# SADDLE CREST HOMES FINAL EIR

## Additional Responses to Comments

Prepared for  
County of Orange

September 2012

**Figure 3.1**  
Jurisdictional Control of  
Santiago Canyon Road

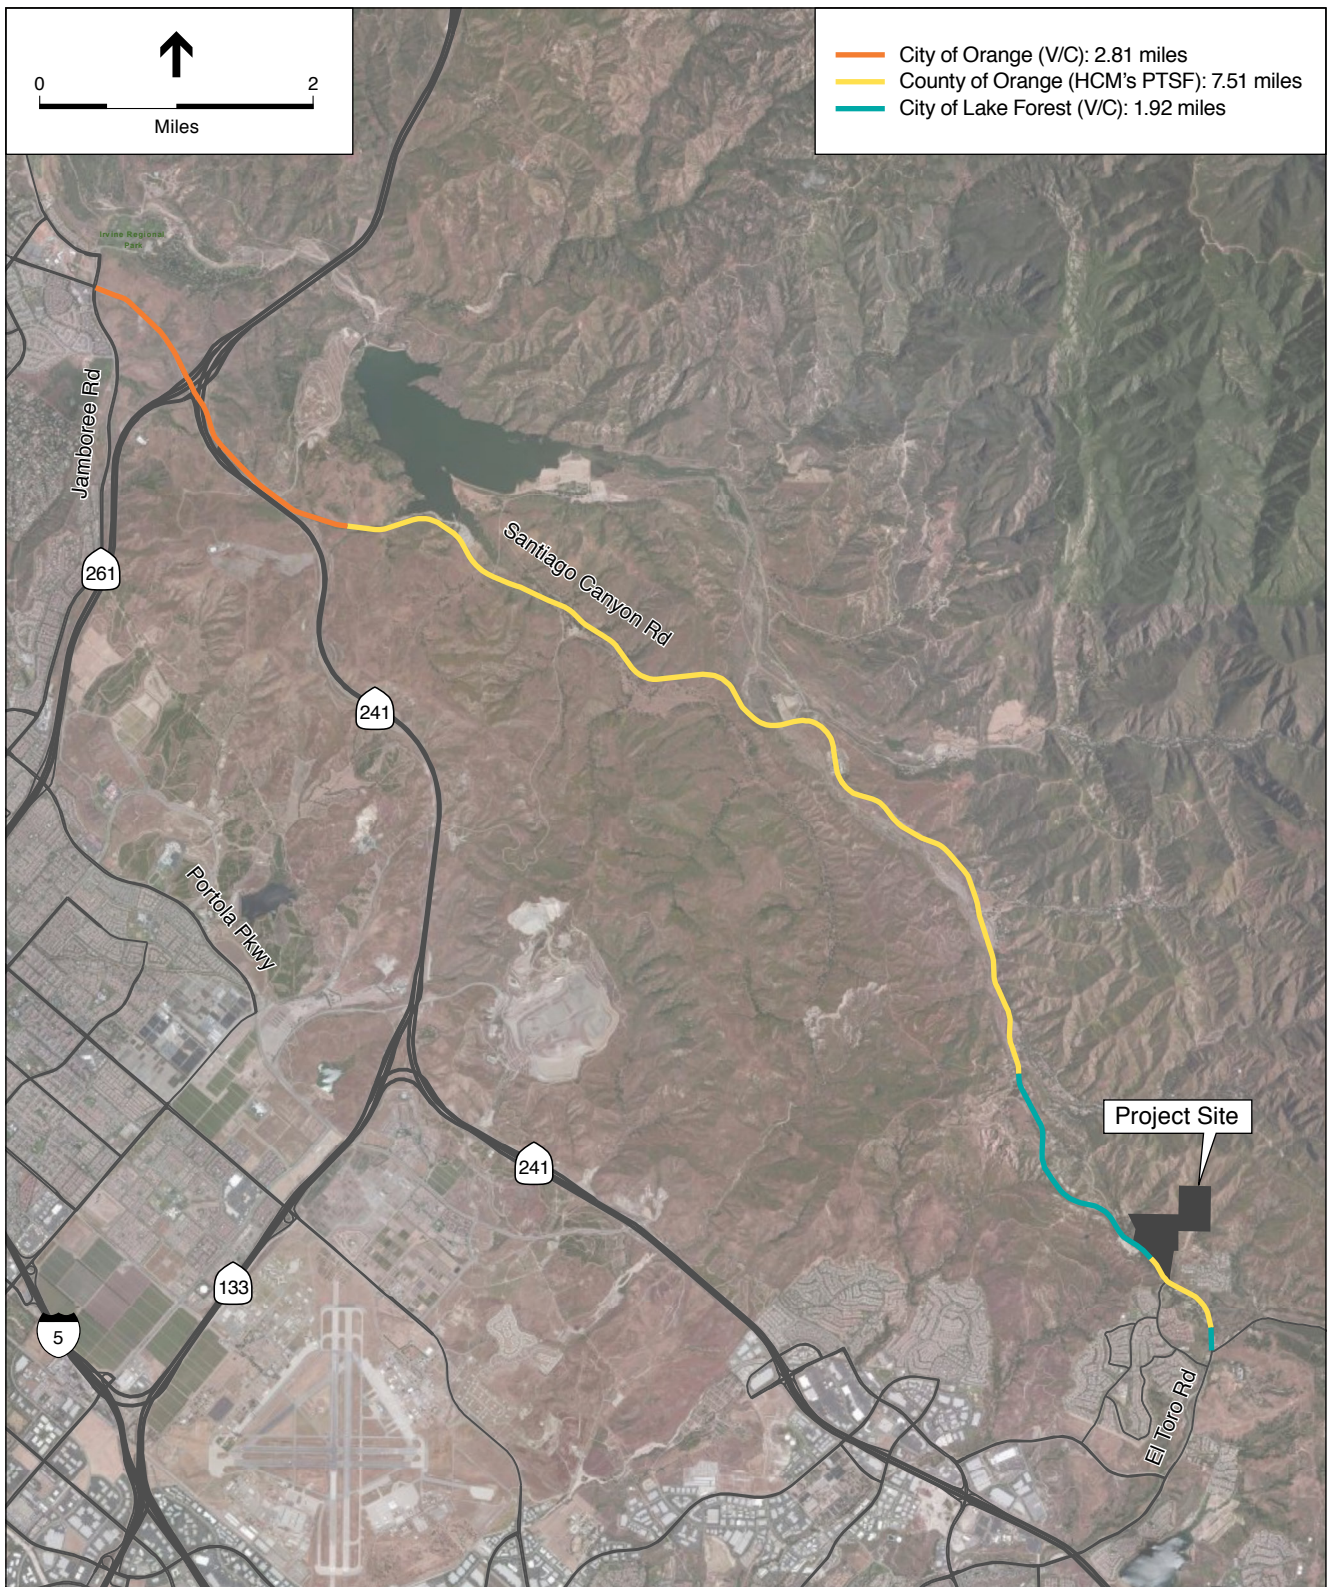
**Page 3-102 of the Final EIR, Figure 3.1 has been modified and is included at the end of this section.**

Ridgeline Road North at Santiago Canyon Road  
Sight Distance Review

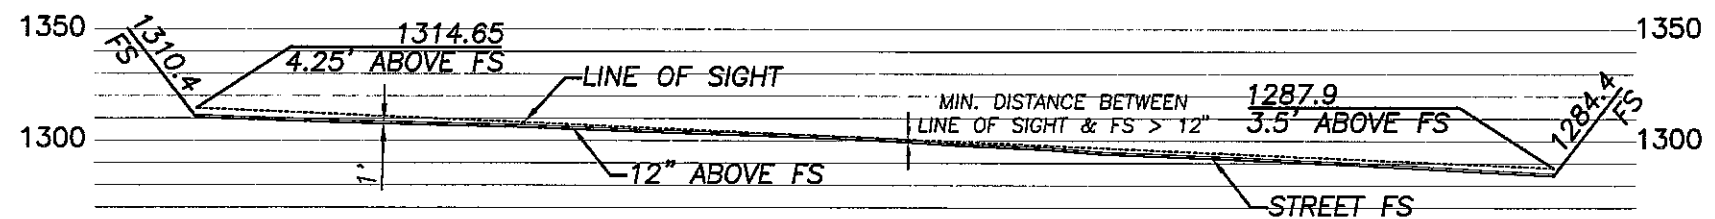
RK has also reviewed this intersection from a sight distance standpoint. By reviewing aerial photographs of the intersection (Appendix C), it appears that there is adequate Santiago Canyon Road at Ridgeline Road North intersection sight distance to accommodate speeds of at least 60 miles per hour. This conclusion of adequacy is based upon Orange County Standard Plan 1117, which defines the required sight distance for various classifications of roadways in Orange County.

Project Access at Santiago Canyon Road  
Sight Distance Review

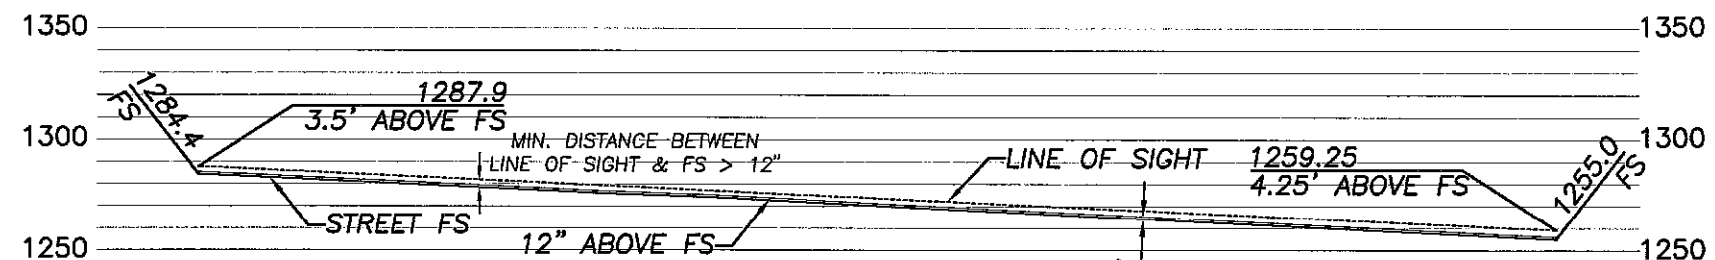
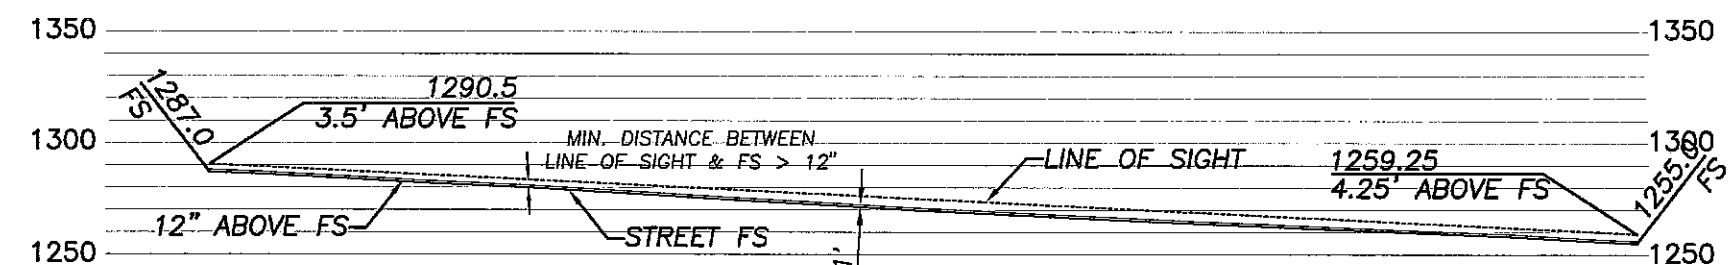
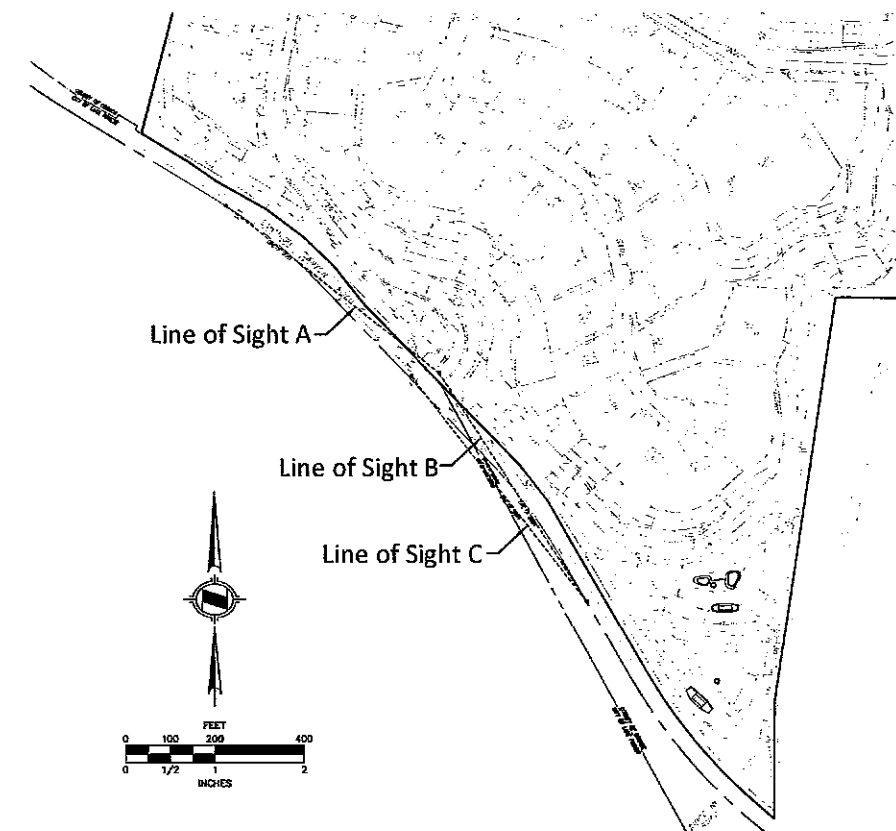
Traffic safety at project access and Santiago Canyon Road has been reviewed in conjunction with the overall design of the project (Appendix D). RK, in conjunction with the project Civil Engineer (Hunsaker & Associates), has reviewed intersection sight distance at the project access and Santiago Canyon Road. The review has been based upon Orange County Standard Plan 1117, which takes into account the required design speed on Santiago Canyon Road and the roadway geometry. Based upon this review, adequate sight distance can be maintained to meet County design standards. Furthermore, the traffic impact study did review the intersection from a capacity standpoint and, for Year 2035 conditions with the project, the intersection would continue to operate at a

good level of service "C", in both the AM and PM peak hour. Based upon this information, it is not anticipated that traffic safety issues would occur at the proposed project access and Santiago Canyon Road.
